INDIANA DEPARTMENT OF TRANSPORTATION

STANDARDS COMMITTEE MEETING

APPROVED MINUTES

January 15, 2009 Standards Committee Meeting

506-CCPP-01 CONCRETE PAVEMENT PATCH DETAILS

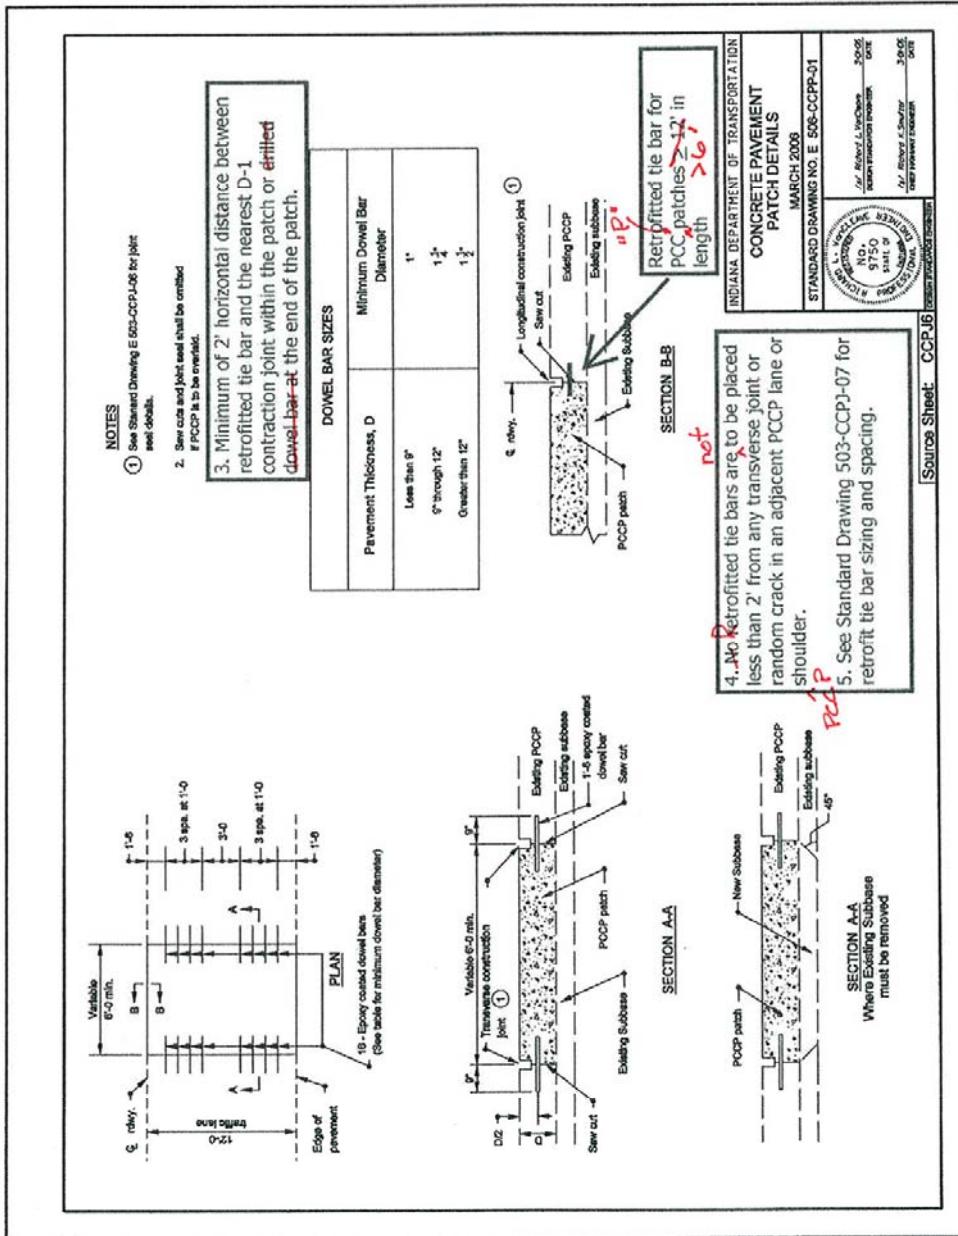
REVISION TO STANDARD DRAWING AND 2008 STANDARD SPECIFICATIONS

506.12 Method of Measurement

SECTION 506, BEGIN LINE 279, DELETE AND INSERT AS FOLLOWS:

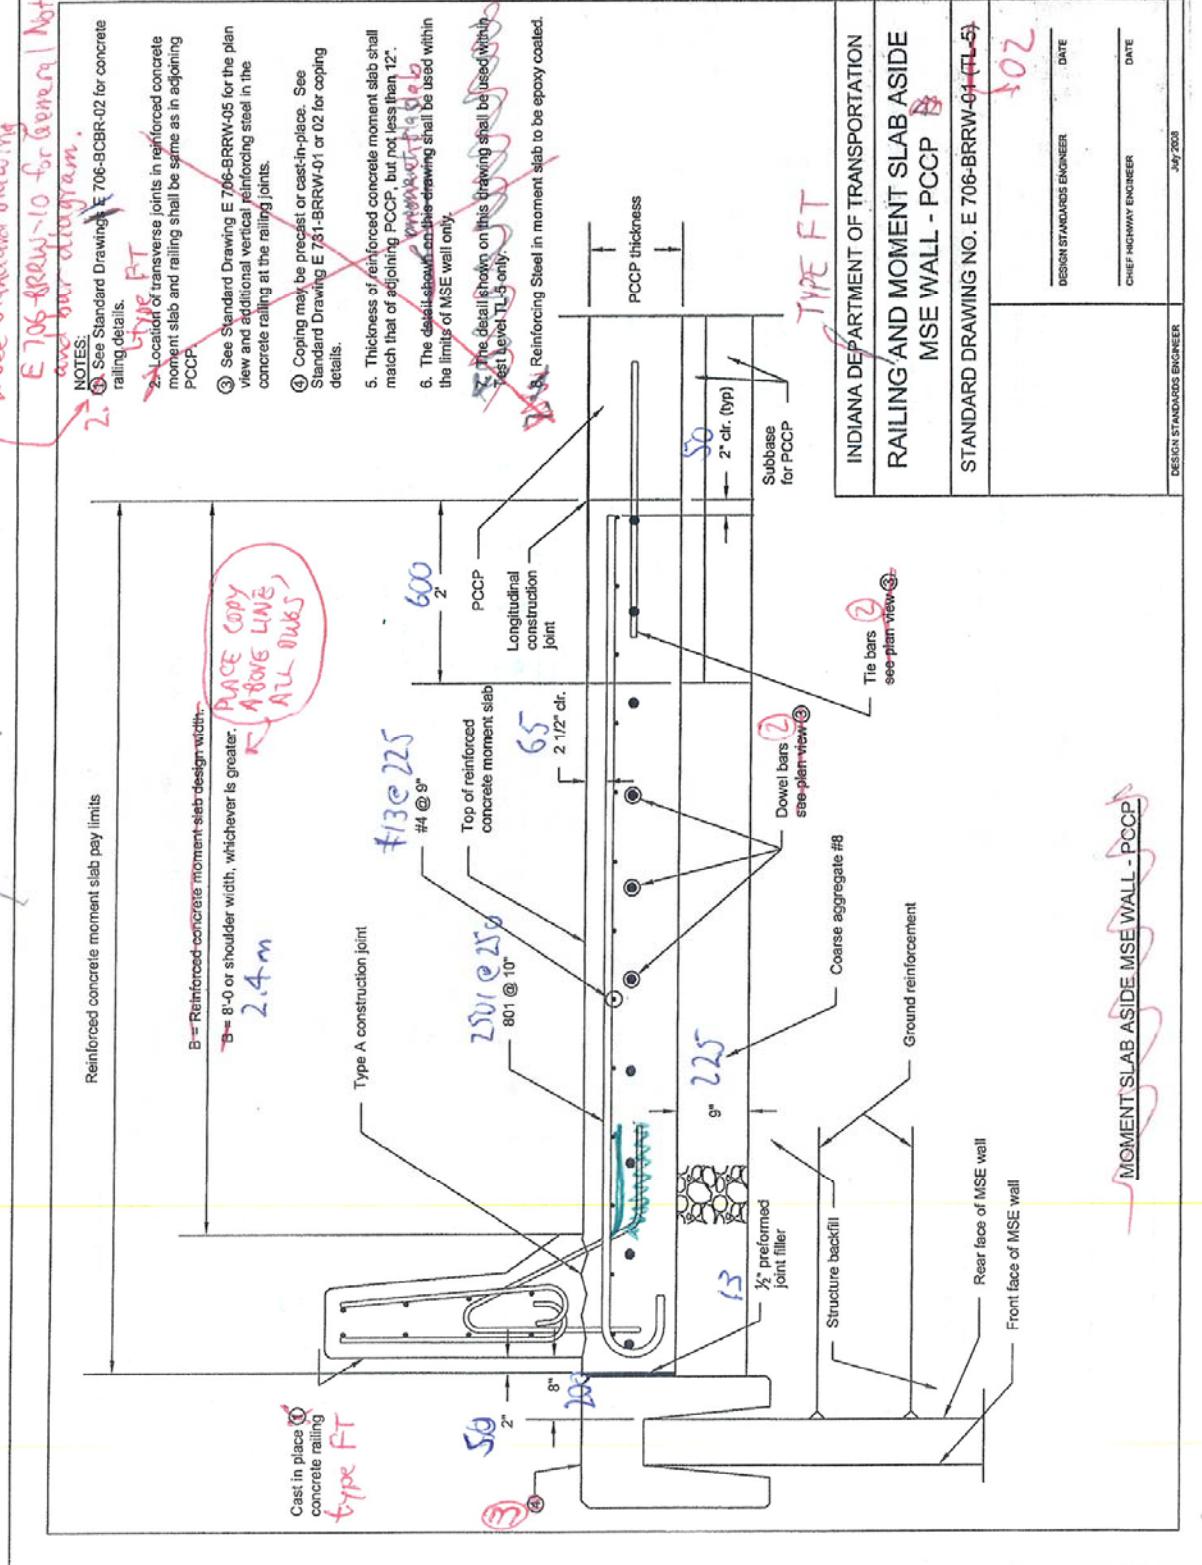
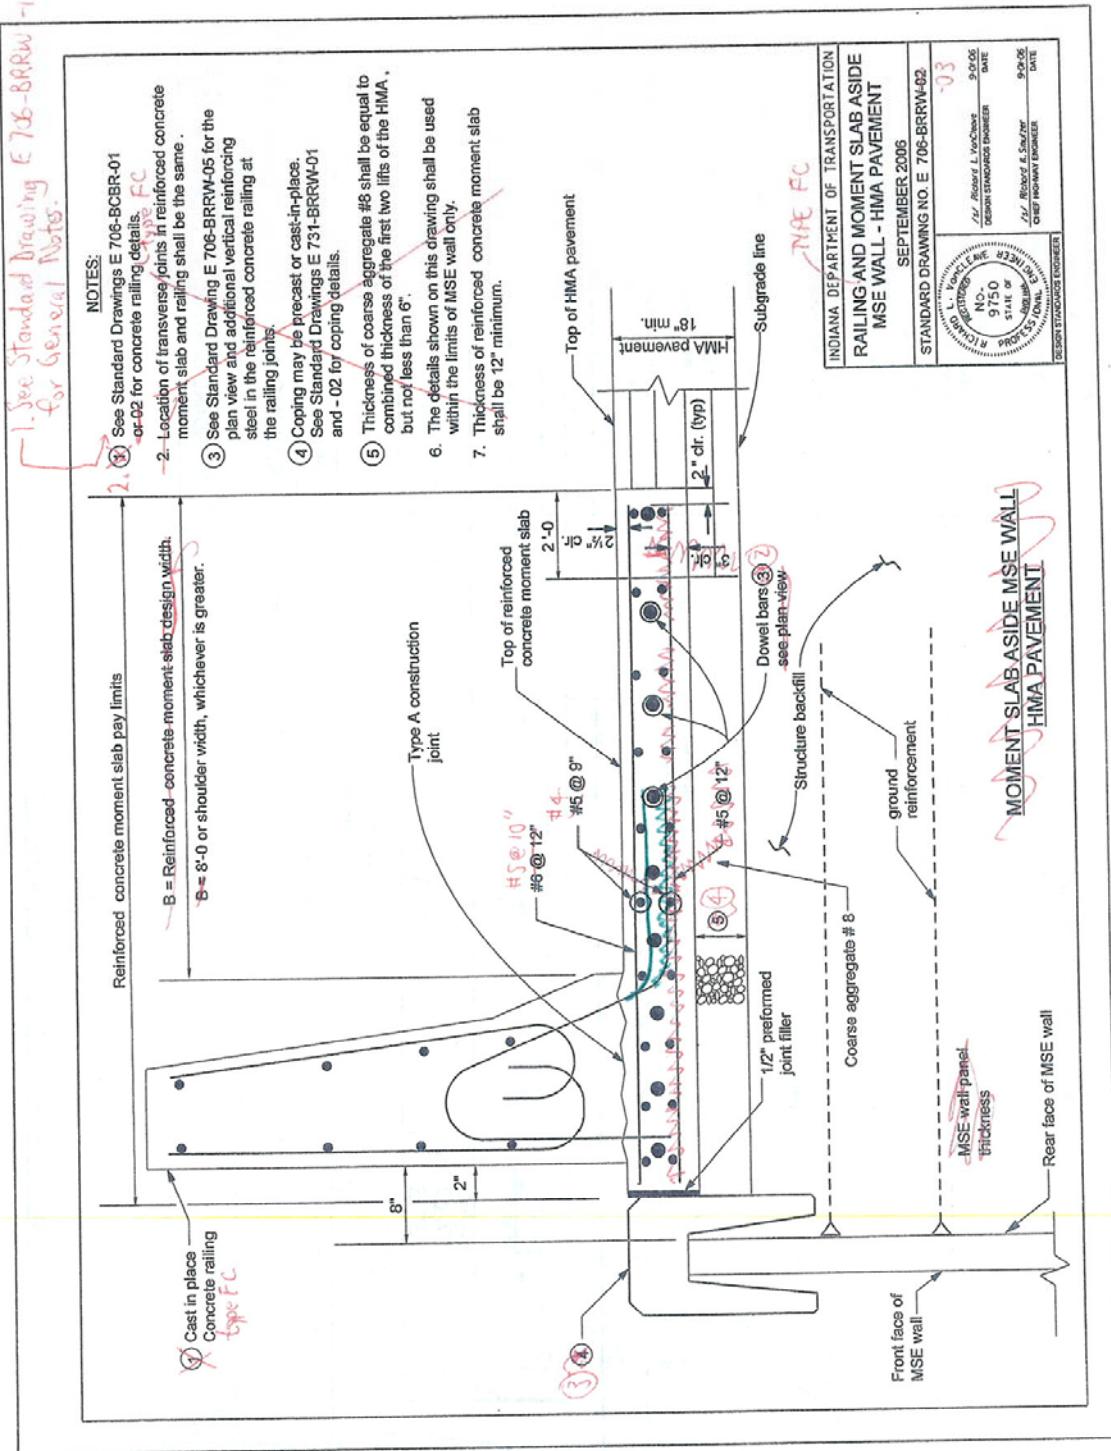
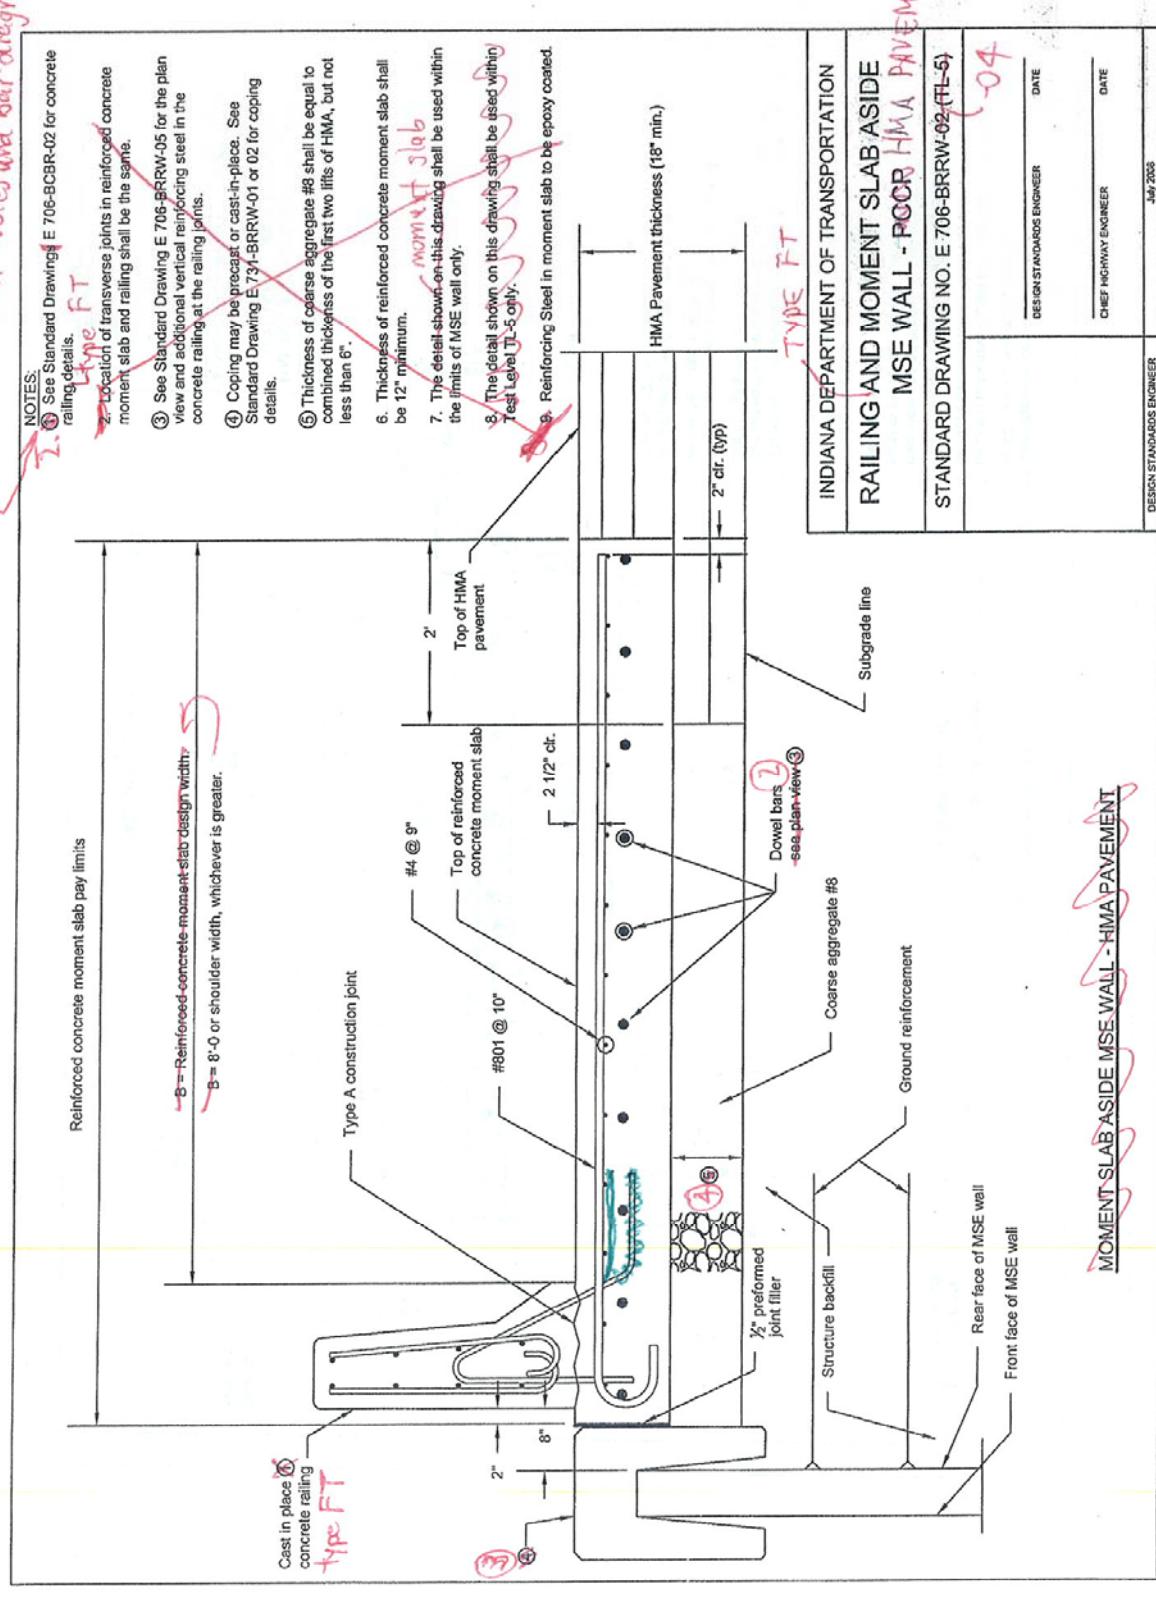
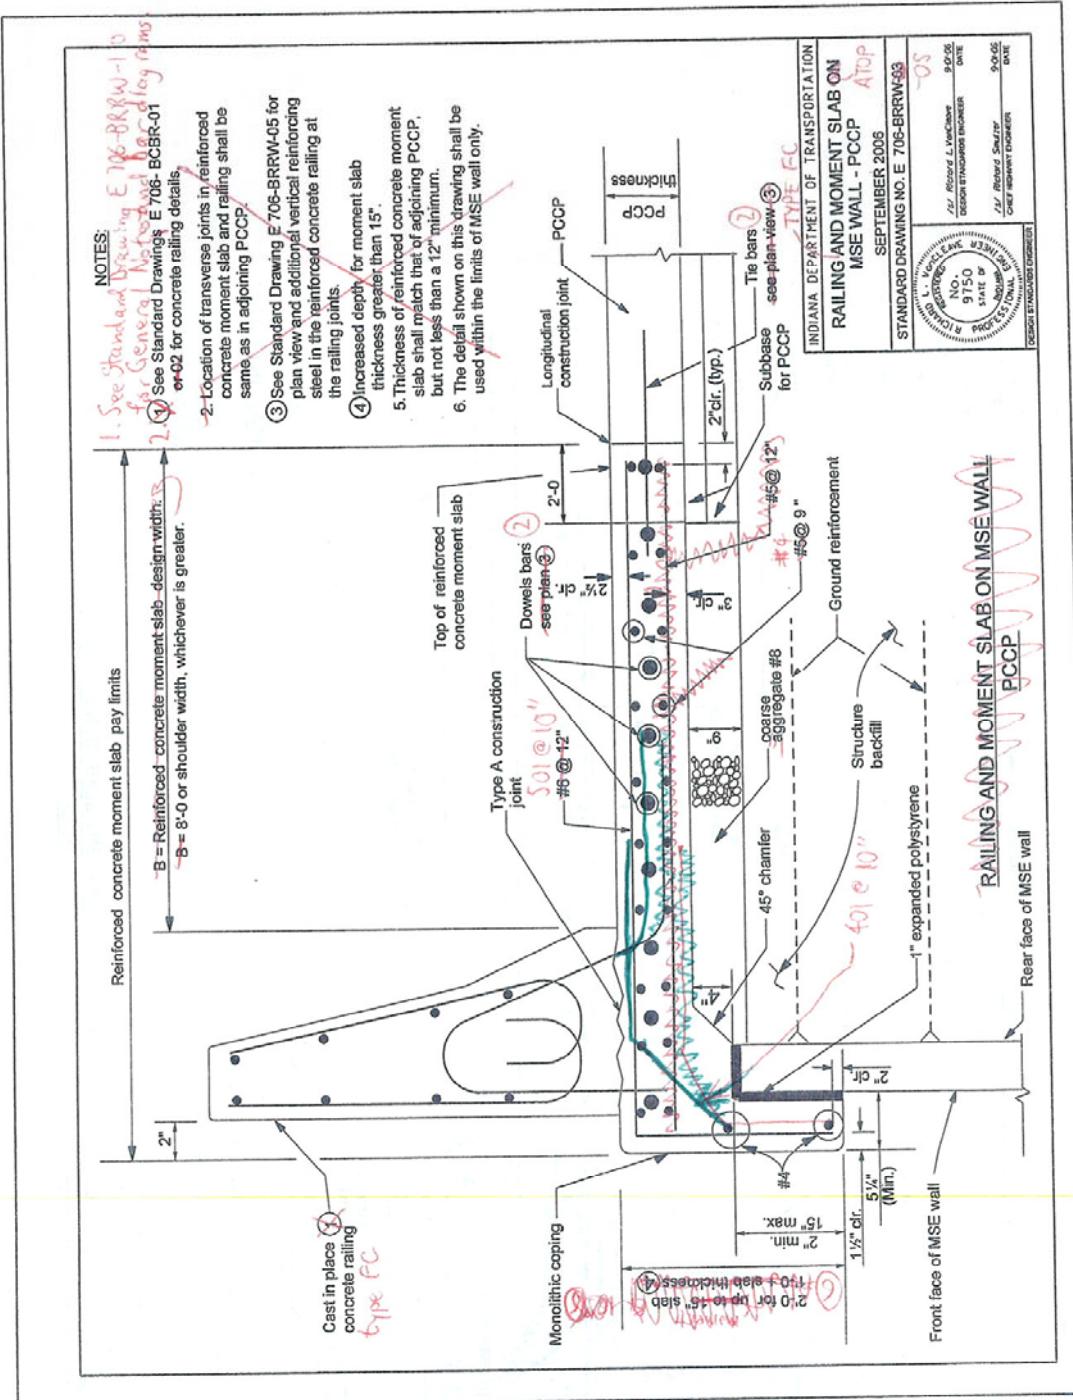
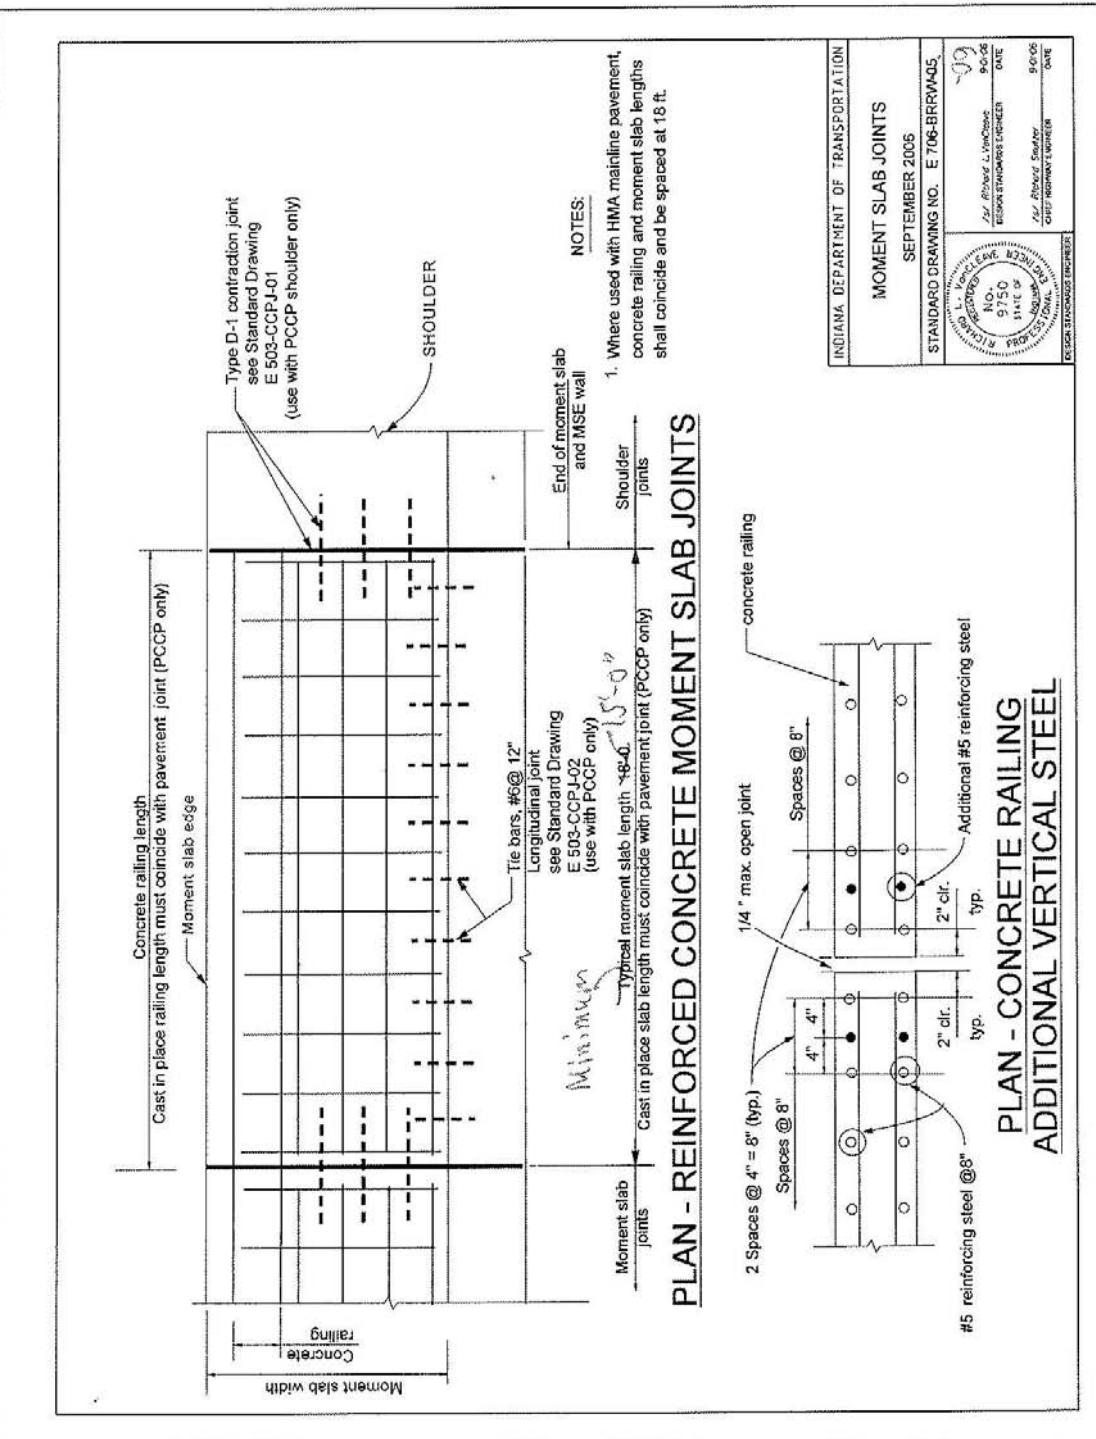
Existing standard drawings 706-BCBR-01, -02, and -04 for concrete bridge railings are being revised to identify the common- and truck-height railings by a type designation.

Tony Uremovich handed out corrections to Standard Drawing E706-BRRW 01 thru 08 and E706-BRRW-10.
